RILEY MOUNTAIN ENGINEERING, LLC

RE: Isle on Inks Lake Development

Subject: Floodplain modeling for The Isle on Inks Lake Development

Subject: Isle on Inks Lake Floodway Review

Figure 4: Modified Cross Section Showing Proposed Development at Avg. Elev. of 892'

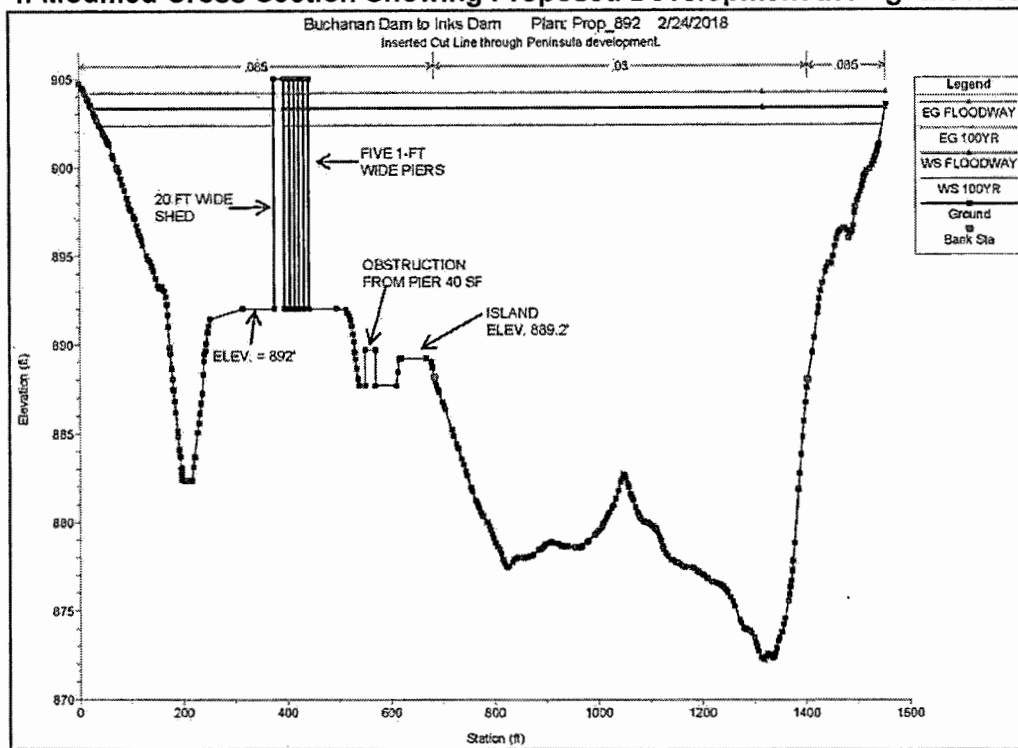
After reviewing the documentation referenced above, along with the HEC-RAS model provided, I concur with the conclusions reached by Mr. Kaough and Mr. Shaw, which are:

The proposed improvements, including excavation to elevation 892 feet, will create no increase in water surface elevations. This condition meets the basic requirement in Section E.1 of the current Burnet County Flood Damage Prevention Order.

Other permit requirements may remain outstanding, which should be addressed separately. Final detailed design of the project will be the responsibility of the design engineers, and final construction drawings should clearly confirm the improvements reflected in the model study and also should adequately address the following issues:

1. Elevation data (an elevation certificate should be obtained),
2. Include structural components sufficient to resist collapse or overturning due to flow velocities, including the effects of accumulated debris, and,
3. Provide for anchorage sufficient to resist buoyancy and/or flotation.

Figure 5: Modified Cross Section Showing Proposed Development at Avg. Elev. of 894'

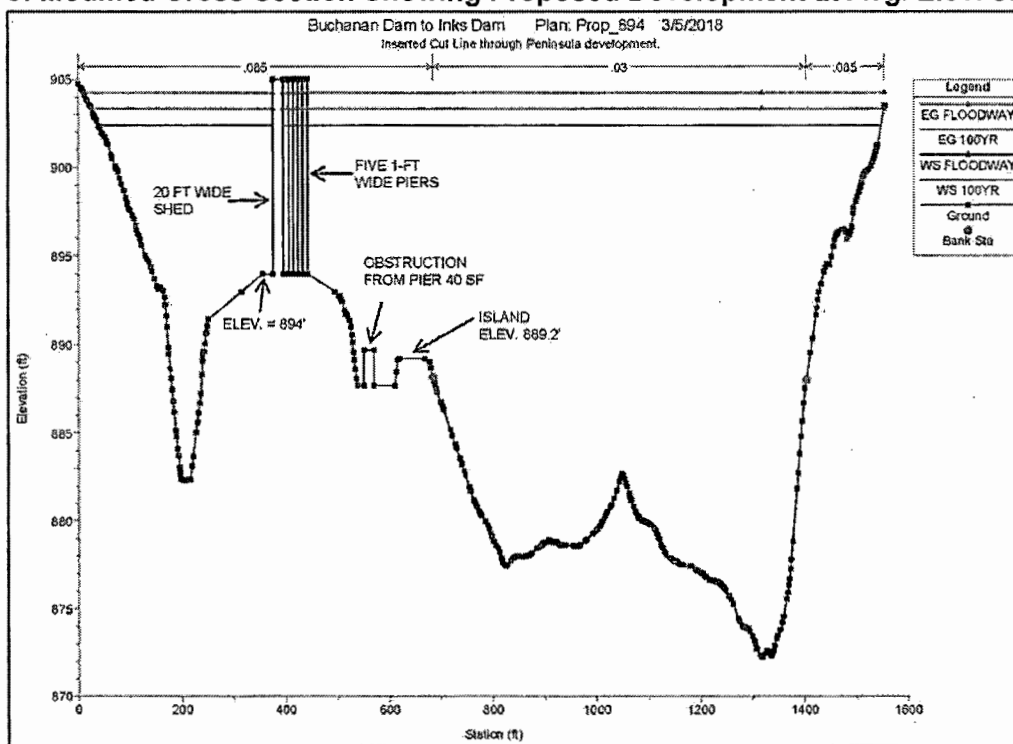
Figure 5 shows the proposed condition cross section graded to an average elevation of 894'.

Two conditions were modeled with different grading elevations of the peninsula 892' (Table 1) and 894' (Table 2).
